Letter Amendment to Administrative Decision NSA-12-05-L2

PROJECT: To construct a redundant transformer sequence (transformer, breaker,

voltage regulator, regulator bypass structure, and underground conduits) within the fenced area at the existing Underwood Substation, and to install an oil and water separator vault and grass lined swale outside of

LOCATION: 331 Newell Road, Underwood; Section 15 of T3N, R10E, W.M. and

MODIFIED SITE PLAN - NSA-12-05-L2 APPROVED FEBRUARY 25, 2016

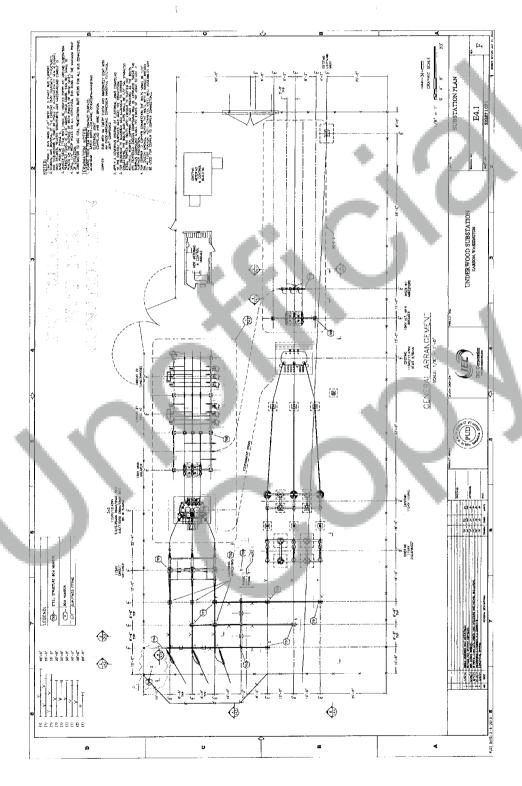
On February 23, 2016, we received a NSA Letter Amendment Application proposing to again modify the approval. The approved plans call for the removal and replacement of the old 12 ft. \times 16 ft. control building with a new 10 ft. \times 20 ft. building. As the project has progressed it was determined that the new control building does not contain enough storage area for parts needed for operation of maintenance of the substation which need to be located onsite in a heated enclosure. As a result, the old control building will remain in place and not removed as initially planned. Both the new building and this existing building are located within the existing fenced substation area.

Bonneville Power Administration (BPA) recently transferred the electric supply feed to the new substation facilities and it was determined that the new electric supply feed does not meet vertical clearance requirements where the power line crosses the substation fencing into the substation yard area. Approximately 45 ft. of fencing at the northeast corner of the substation will be bumped out to achieve the proper vertical ground clearance. The new fencing will be 6 ft. chain link to match the existing fencing. Additionally, substation construction standards require the existing ground grid to be extended out 5 ft. past the new fencing. The ground grid includes subsurface copper conductors. The area where the fencing and ground grid will be extended consists of large boulders, gravel, and dirt. The large boulders will be cleared out of this area and approximately 75 cu. yd. of compacted roadbed material and crushed rock will be used to bring this area up to existing grade and create the ground grid. This area has been previously disturbed during the initial construction of the substation and subsequent projects and was included in the cultural resources reconnaissance survey for this project.

As part of the Underwood Substation Upgrade Project, Skamania PUD applied for and received National Scenic Area Site Plan Approval (NSA-12-05) to allow necessary upgrades to the Underwood Substation. In 2015, Skamania PUD started construction on the project and has since completed most of the structural changes, energized the new transformer, and is actively using the new facilities. The approved plans for this project showed removal of the old control building once the new control building was in use. However, the PUD has identified that the new control building does not contain enough storage space to accommodate the 6-foot long spare fuses and other spare parts needed for operation and maintenance of the substation. The fuses and other spare parts need to be located onsite in a heated enclosure. Therefore, instead of building a new storage area the PUD is requesting an amendment to the original plans in order to keep the original control building for additional storage space. The attached drawings shows the location of the original control building that the PUD would like to retain.

Bonneville Power Administration (BPA) recently transferred the electric supply feed to the new PUD substation facilities. BPA then notified the PUD that the electric supply feed does not meet vertical clearance requirements where the power line crosses the substation fencing into the substation yard. The power line slopes downward from the BPA feed pole towards the substation; therefore the best solution to correct this deficiency is to move the chain link fencing out (northward) approximately 10 feet to where the vertical clearance requirements are satisfied. Overall, approximately 45 feet of the existing fencing at the northeast corner of the substation will need to be bumped out to achieve the proper vertical clearance. Substation construction standards require the existing ground grid (subsurface grid of copper conductor spaced at approximately 2 foot between conductors) to be extended out 5 feet past the new fencing. The ground grid is required to prevent electric shock hazard for personnel working inside the substation and anyone who may touch the substation fence from the outside. The ground where the fencing and ground grid will be extended consists of large boulders, gravel and dirt that was previously disturbed during the initial substation construction and subsequent improvement projects. The large boulders will be cleared out of this area and approximately 75 cubic yards of compacted roadbed material and crushed rock will be added to bring the area up to existing grade and create the ground grid.

The modified site plans attached to this Letter Amendment (see pp. 10-11) shall replace the ones attached to the Administrative Decision. The amendment is hereby approved.
